SUNDRY NOTICES AND REPORTS ON WELLS
Do not use this form for proposals to drill or to re-enter an abandoned well. Use Form 3160-3 (APD) for such proposals.

San Juan 28-7 Unit 242

Attachment to notice of Intent to Recomplete & Commingle

CONDITIONS OF APPROVAL

Well Name: SAN JUAN 28-7 UNIT 242

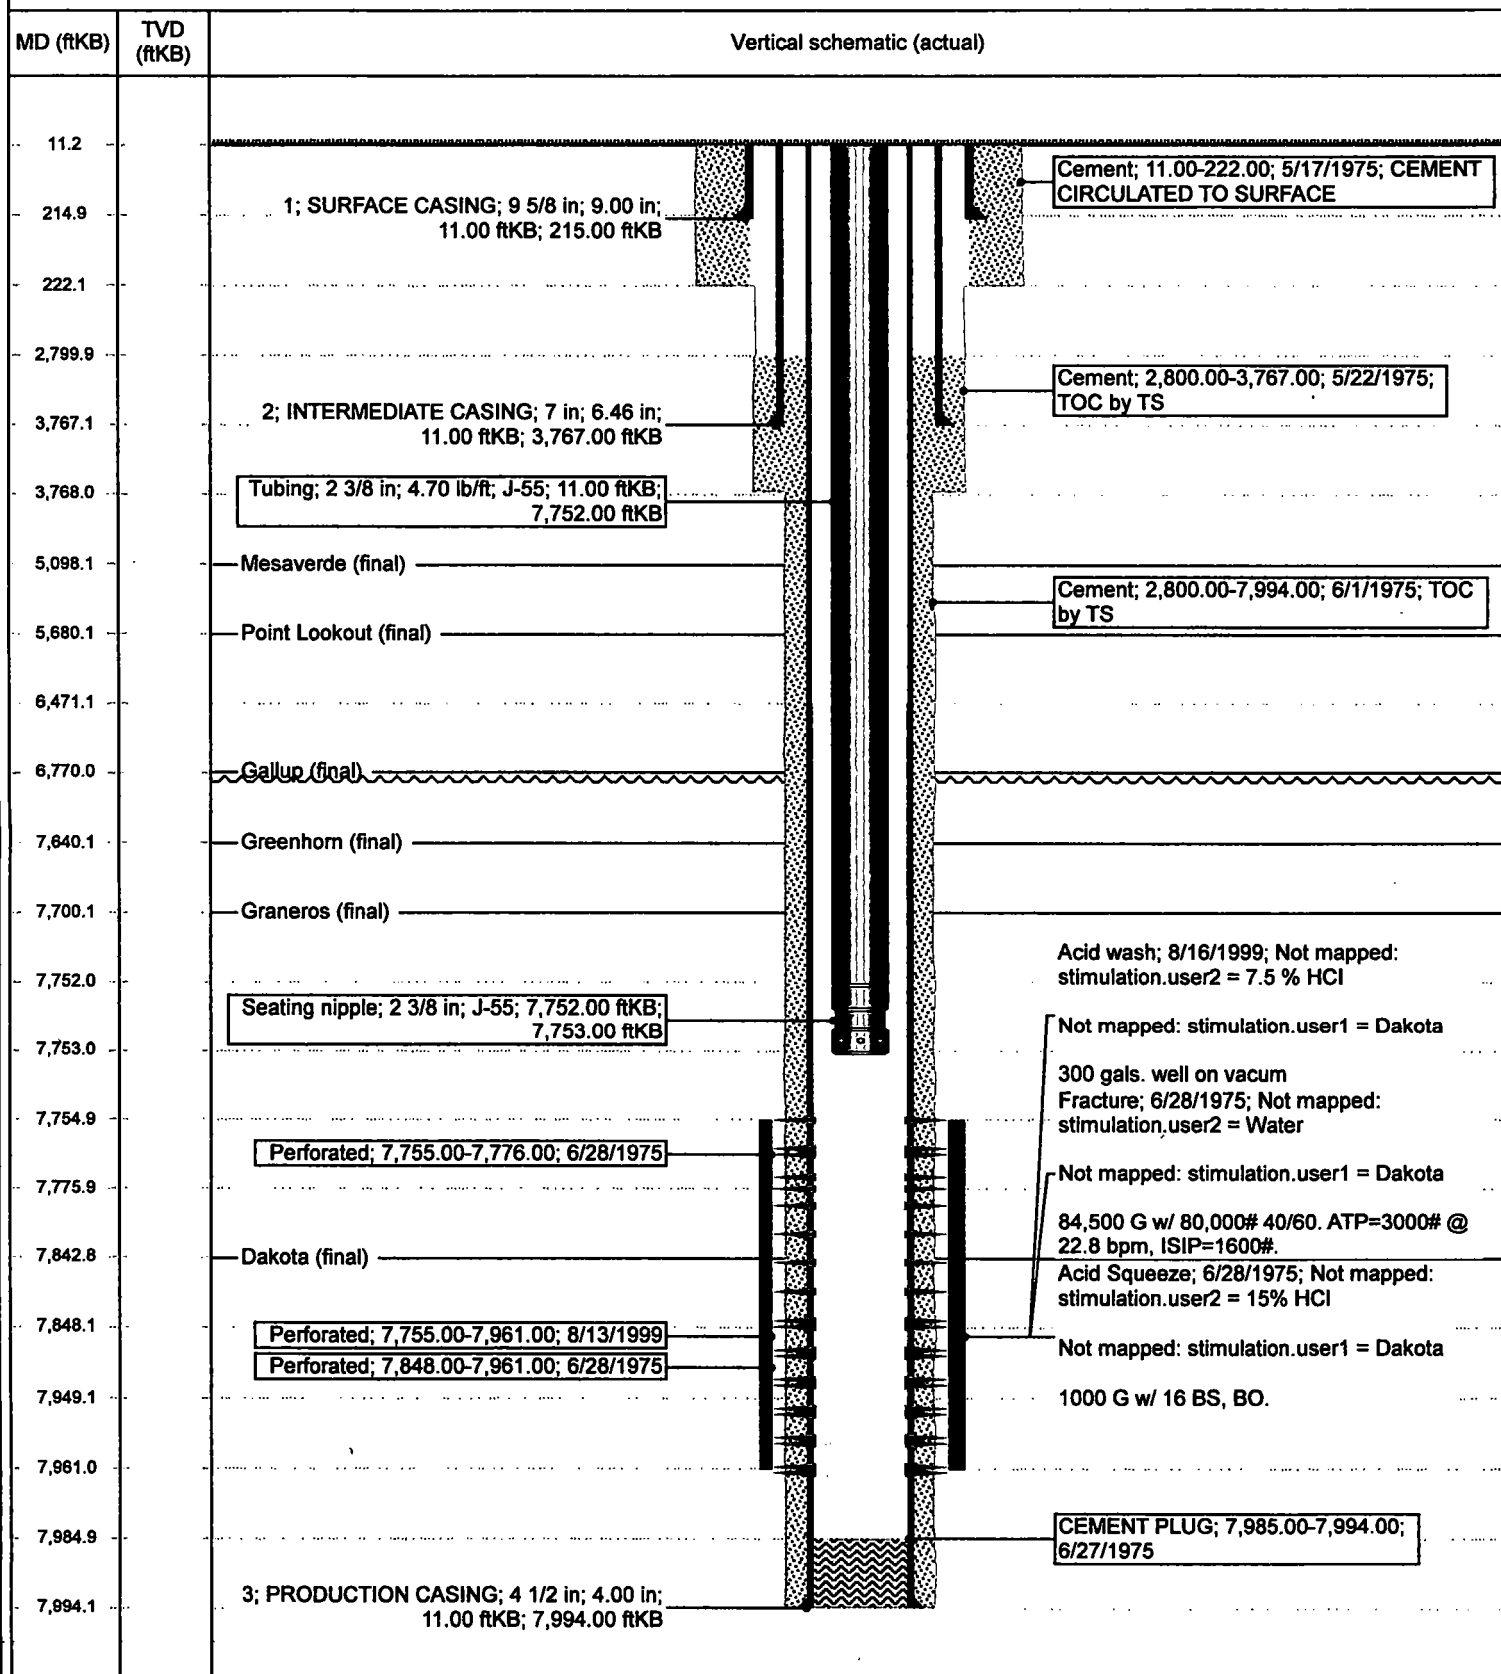
2. The following modifications to your recompletion program are to be made:

- a) Upon rigging up, record Bradenhead pressure and monitor same during recompletion operations. Notify BLM and NMOCD if anomalous pressure changes occur. Provide monitoring results in the subsequent Report of Operations.
- b) Casing pressure test for fracture stimulation operations cannot exceed the internal yield strength of the casing including a 20% safety factor unless a waiver is granted. Stimulation operations cannot exceed this test pressure.
- c) CIBP for base of fracture stimulation to be set less 50' above top existing perforation.
